BIOLOGICAL ASSESSMENT

616 COLD CANYON ROAD, CALABASAS

RPPL-2023005937

SUBJECT: Arborist Reply to LA County comments – 616 Cold Canyon Rd. Calabasas, CA

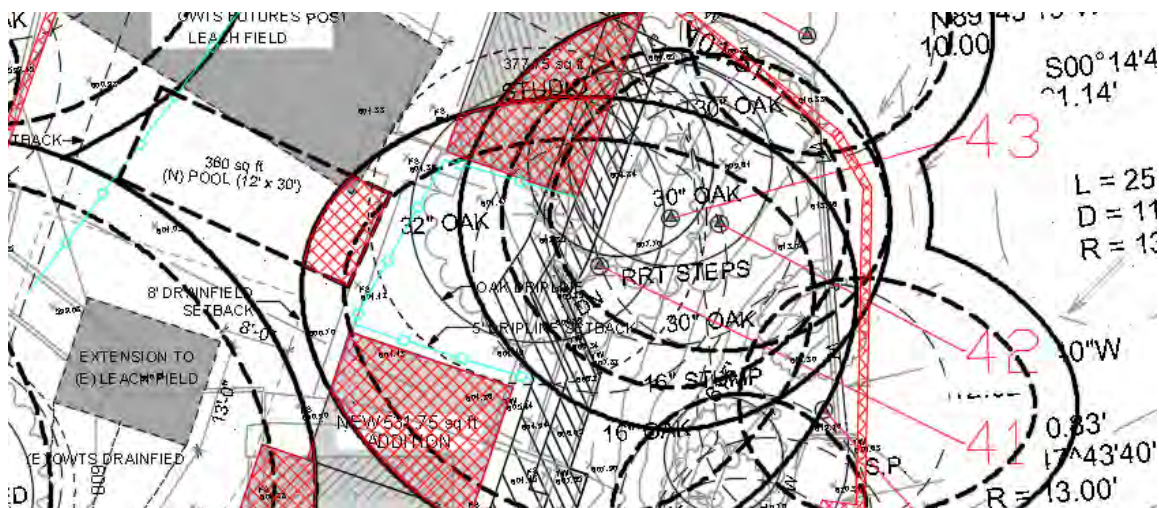
Planners Note:

Please ensure consistency between and within documents by making the following revisions:

1. amend the arborist's report to include an inclusive table of all tree data for on-site and adjacent off-site trees, including any existing or proposed encroachments or removals.
2. include the tree data table in the Biological Inventory and revise any discussions accordingly.

Arborist reply: the inclusive table of all tree data for on-site and adjacent off-site trees was actually included in the report on the pages following this comment. See this table on pages 33 through 42 of the tree report.
